MONTGOMERY COUNTY HISTORIC PRESERVATION COMMISSION
STAFF REPORT

Address:	10221 Menlo Ave., Silver Spring	Meeting Date:	3/26/2025
Resource:	1870-1916 Capitol View Park Historic District	Report Date:	3/19/2025
Contact:	Beth Davis, Project Agent	Public Notice:	3/12/2025
Review:	Historic Area Work Permit	Tax Credit:	n/a
Permit Number:	1079660	Staff:	Dan Bruechert
Proposal:	Construction of New Single-Family House and grading and hardscape alterations

Figure 3: Revised front elevation (left) and previous proposal (right).

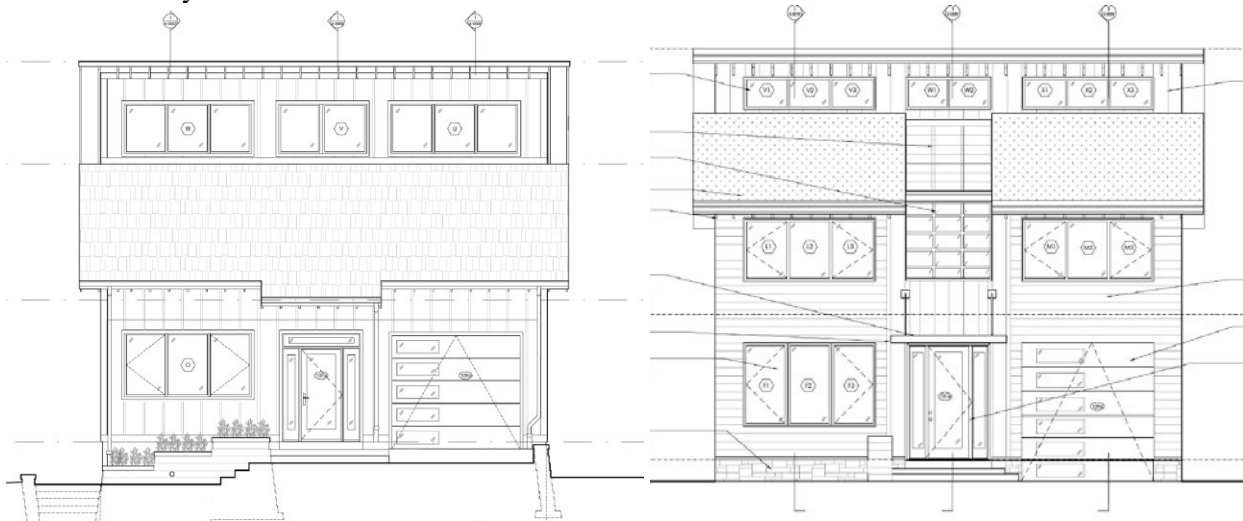
The house has a central entrance with a one-bay garage on the right. A window, matching the width of the garage door, is proposed to the left of the front door (see *Figure 2*, above). The right elevation has two rows of windows located on the rear half of the wall, while the left elevation has five rows of windows. The rear elevation includes two wide banks of windows, though the revised design removed the second story windows.

Staff finds the proposed design, though distinctly contemporary, will not detract from the character of the surrounding district. The roof form, window size and scale are all intended to stand apart from the historic buildings and historic building styles found throughout the historic district. Increasing the roof pitch also has the effect of reducing the house mass closer to the street. Staff finds the proposed house's siting, massing, proportions, and materials (all discussed below) and not necessarily its stylistic elements are what makes the proposed design appropriate under *Standard 9* which encourages compatibility while differentiating between new and historic elements.

Staff finds the current design balances the width of the front elevation openings, which creates an appearance with a more highly glazed percentage of wall surface. At the previous Preliminary Consultation, the commissioners were more concerned about the compatibility of the translucent wall/roof system and the green roof than the fenestration at the front. Staff finds the proposed fenestration on the left and right elevations has been simplified by eliminating the vertical metal panels between the windows and better stacked the window openings. Staff finds that the largely blank south (right) wall could benefit from additional fenestration, but also recognizes that the fenestration is consistent with the house's overall contemporary aesthetic and does not find it is necessary to add fenestration to this wall to find its design is compatible with the character of the district.
